Access Compliance Report

Public Rights-of-Way

Intersection ID: 12165	Main Street: E_15TH_ST	Cross Street: HARRILL_ST	Location: E
ADA ID: 6642D5DC2C51	Ramp Type: PerpDiag	Initial Pass/Fail: Fail	Overall Compliance: No
		Severity Score: 8.75

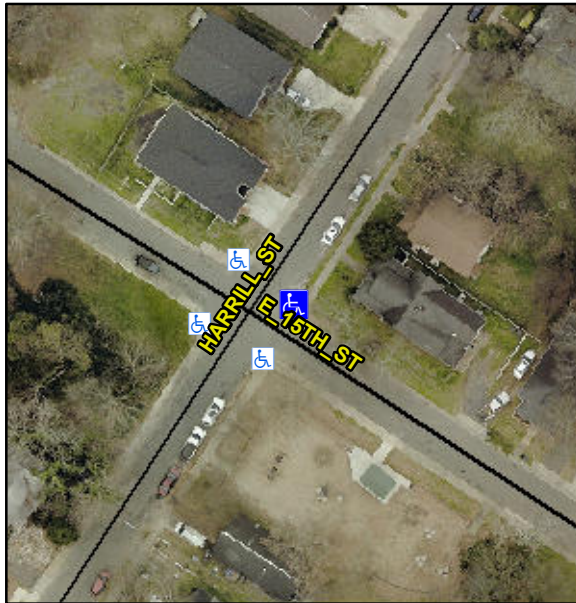
Not Found, R304.5.1

Compliance	Description	Data	Compliance	Description	Data
N/A	Ramp Length (in)	44.0	Yes	Ramp Slope (%)	6.2
No	Ramp Width (in)	46.0	Yes	Ramp XSlope (%)	1.8
N/A	Flare Type LT	N/A	N/A	Flare Type RT	N/A
N/A	Flare Slope LT (%)	N/A	N/A	Flare Slope RT (%)	N/A
N/A	Flare Traversable LT?	N/A	N/A	Flare Traversable RT?	N/A
N/A	Landing Length (in)	N/A	N/A	DWS Provided?	N/A
N/A	Landing Width (in)	N/A	N/A	DWS Contrast?	N/A
N/A	Landing Slope (%)	N/A	N/A	DWS Length (in)	N/A
N/A	Landing X Slope (%)	N/A	N/A	DWS Full Width?	N/A
N/A	Landing Curb? (Y/N)	N/A	N/A	DWS Offset (in)	N/A
N/A	Shared Landing?	N/A			
N/A	Gutter Ponding?	N/A	N/A	Gutter Slope (%)	N/A
N/A	Gutter Lip Ht (in)	0.5	N/A	Gutter X Slope (%)	N/A
N/A	Painted X Walk1?	No	N/A	Painted X Walk2?	No
	X Walk 1 Direction	To NW		X Walk 2 Direction	To SW
N/A	X Walk 1 Width (in)	N/A	N/A	X Walk 2 Width (in)	N/A
	X Walk 1 Slope (%)	1.0		X Walk 2 Slope (%)	2.3
	X Walk 1 X Slope (%)	1.0		X Walk 2 X Slope (%)	1.0

Remove & Replace Curb Ramp With Two New Directional Ramps or Equivalent.
